# 1967 Corvette: Service News: Inspection and Realignment of the Energy Absorbing Steering Column

**Source:** Chevrolet Service News

**Date:** February, 1967 - Volume 39 - Number 2

## **INSPECTION and REALIGNMENT of the ENERGY ABSORBING STEERING COLUMN—ALL 1967 PASSENGER CARS**

## 1967 CORVETTE STEERING COLUMN REALIGNMENT—FIGURE 6

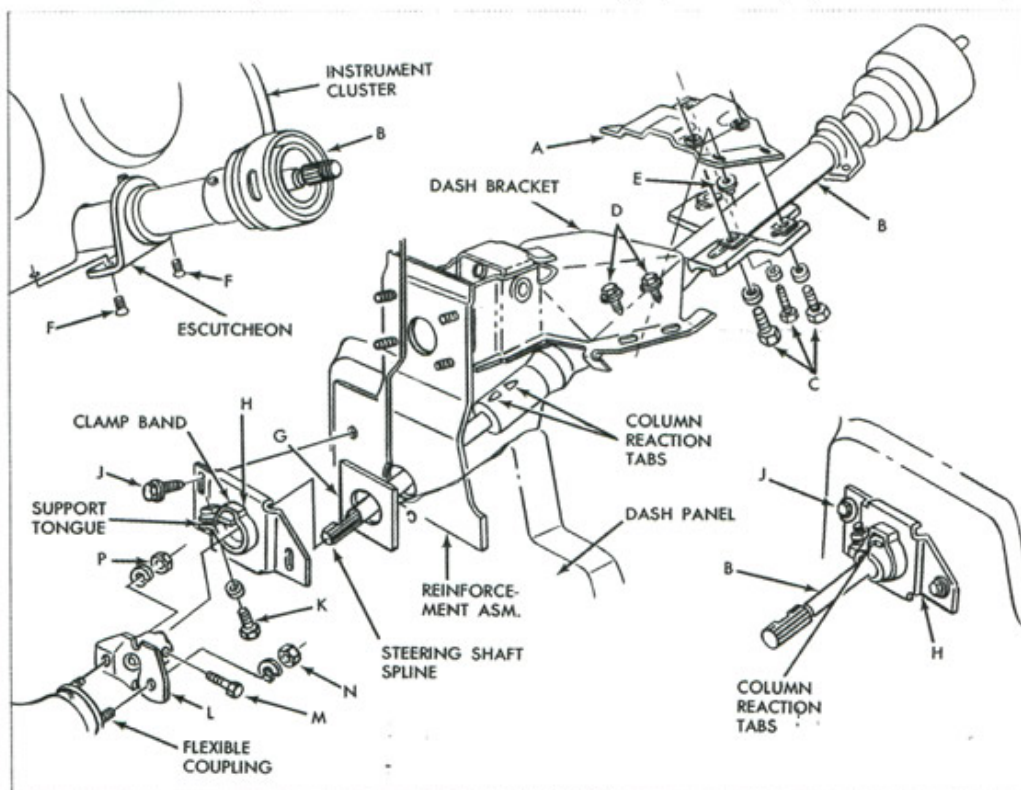
The following information on inspection and realignment of the energy absorbing steering column supplements and supersedes the information published in Section 9 of the 1967 (Passenger Car) Chassis Service Manual and the 1967 Corvair Chassis Shop Manual Supplement.

1. Loosen, but do not remove, escutcheon attaching bolts (F).
2. Loosen, but do not remove, three bolts (C) which attach the column (B) to the intermediate bracket (A). Loosen four nuts (E) and bolts (D) which attach the intermediate bracket (A) to the dash bracket.

3. Loosen bolts (J) and (K) which secure the lower column to the toe pan.
4. Loosen flexible coupling flange pinch bolt (M).
5. Check steering column to insure column is loose and can be moved in all directions.

6. Tighten escutcheon attachment bolts (F) to 25 in.-lbs. torque.
7. Adjust column fore or aft to place the clamp band (part of H) between the column reaction tabs (part of B).

8. With the column position defined by flexible coupling and escutcheon, hold the steering column lower support (H) against the front of dash and tighten the wrap-around clamp bolt (K) to 150 in.-lbs. torque.

9. Check bracket (H) to insure that it is not

binding against bolts (J). Tighten bolts (J) to 150 in.-lbs. torque.

10. Pull intermediate bracket (A) rearward to accommodate the height differential of the

cluster to instrument panel brace, and tighten three bolts (C) to 20 in.-lbs. torque.

11. With flexible coupling held flat, tighten upper flange pinch bolt (M) to 30 ft.-lbs. torque.
